Swanwick Airspace Improvement Programme
Airspace Development 5
Proposed changes to LAC West to improve ATS route connectivity

SAIP AD5
Documentation:
Stage 4 Update and Submit

Step 4A Update Design

Figure 13 L18 GAVGO DIKAS as consulted upon (top) and final proposal (above) – see para 3.7.5

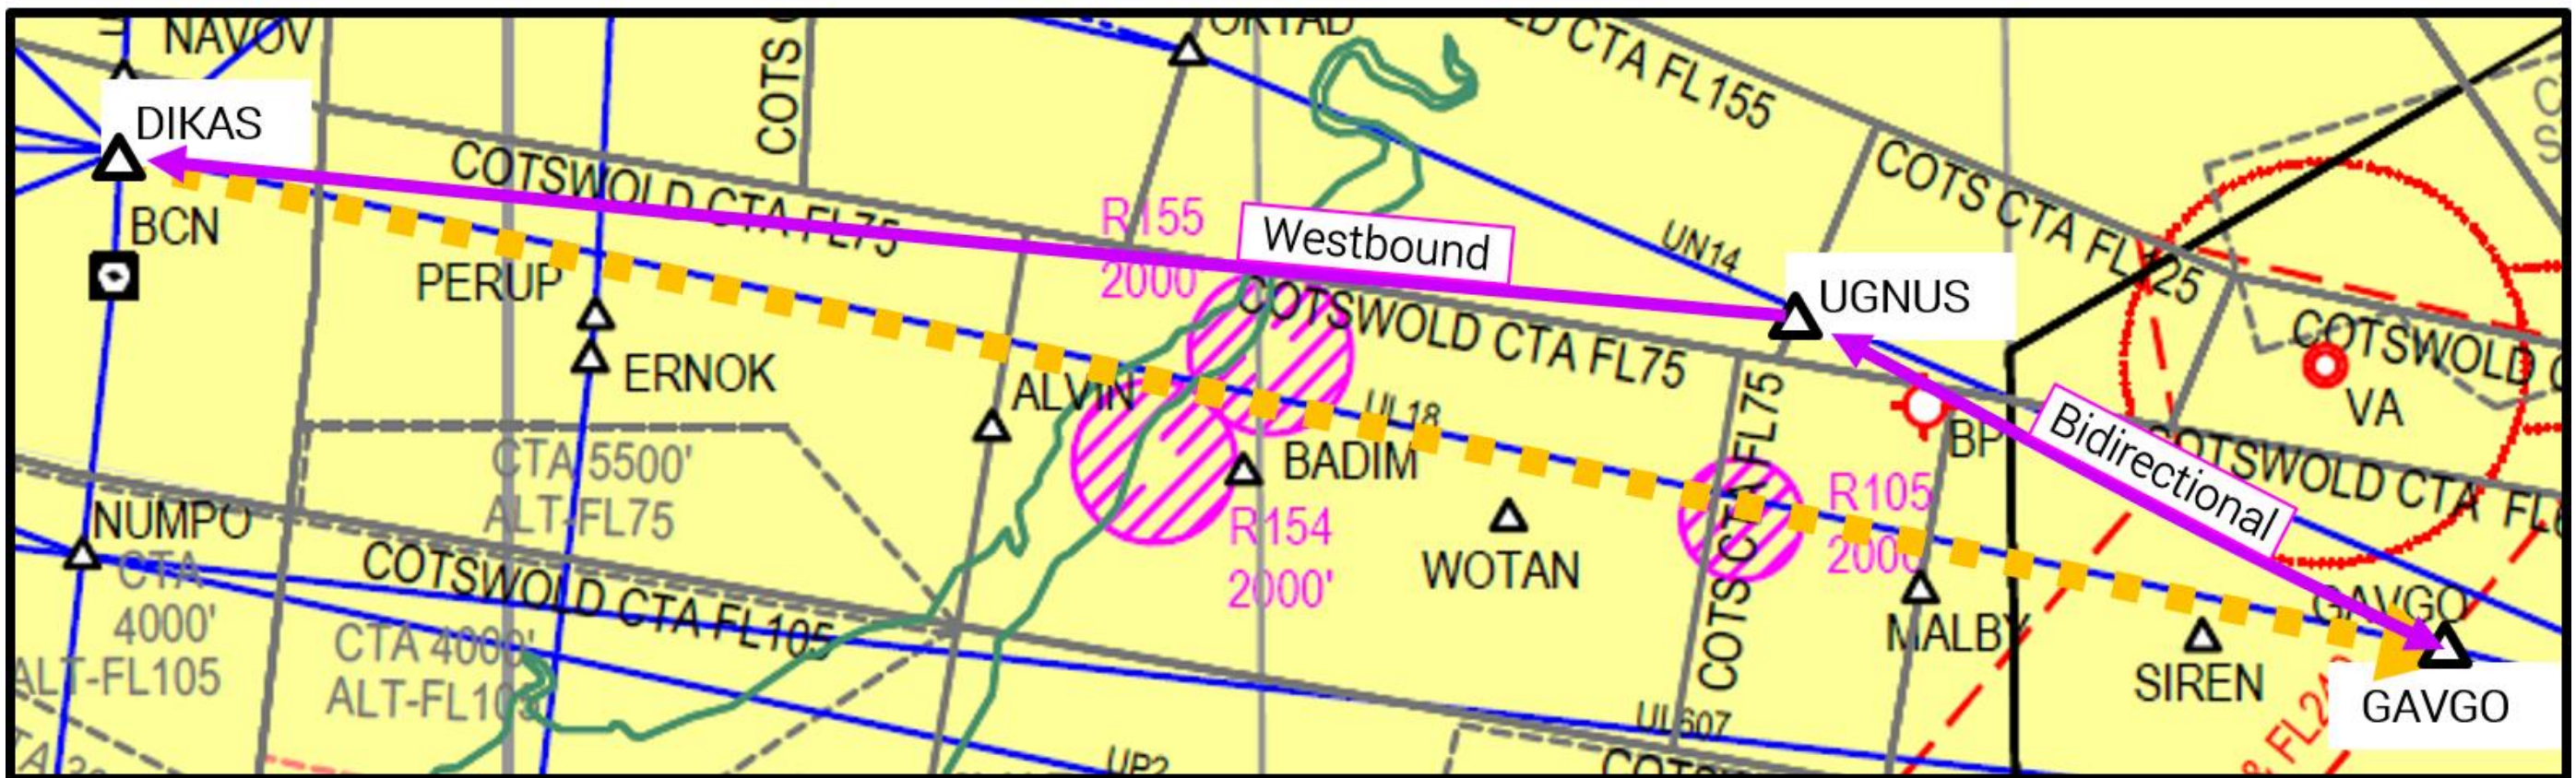
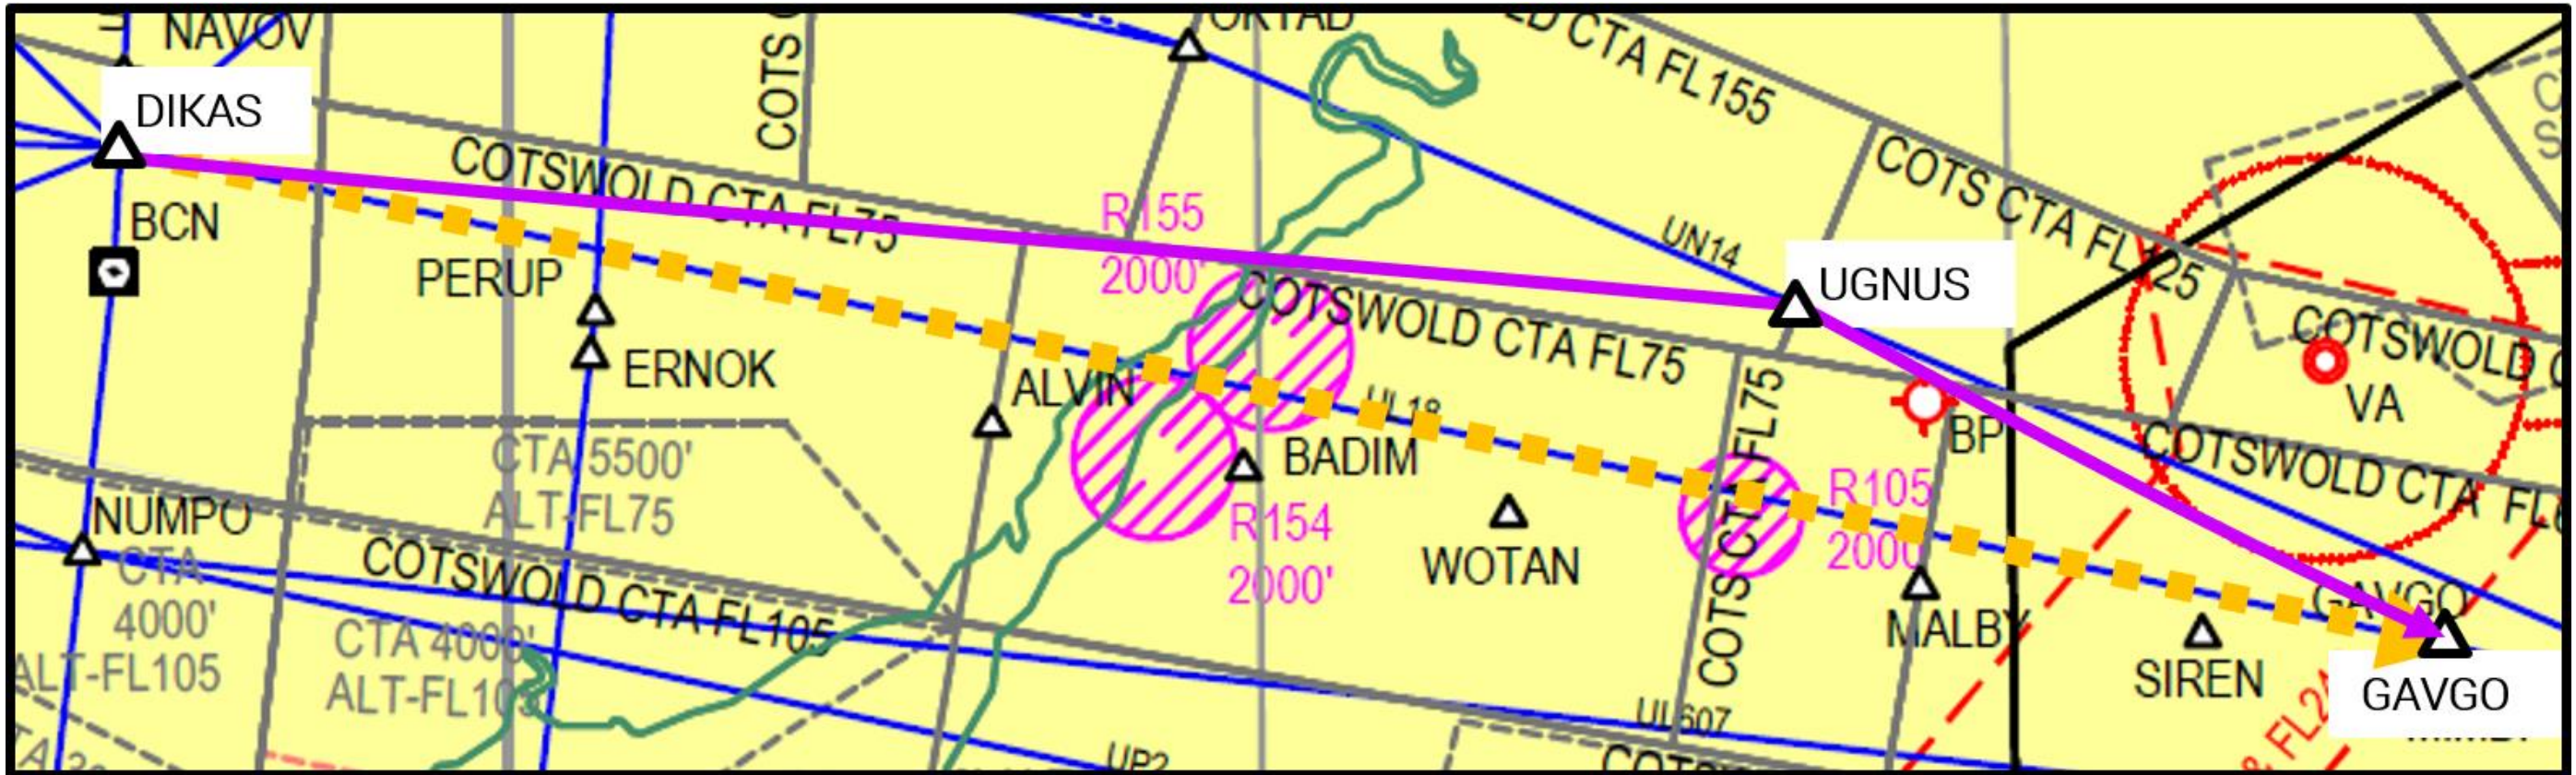
Consultation document Figure 12, this document Figure 13 on page 21.

This route was proposed as an administrative decoupling of L18 from UL9, originally consulted upon to be eastbound only. This aligned with the originally consulted upon Q60/L18 route structure described in the previous para 3.7.4 above, however it did not provide adequate westbound connectivity with the revised flow directions described later in that same paragraph. Thus the directionality of this route has been amended for connectivity and flow direction purpose. It enables the flows in the previous paragraph but does not provide a defined fuel benefit itself, in the same way the originally consulted upon decoupled route enabled the flows in the originally consulted upon Q60/L18 structure.
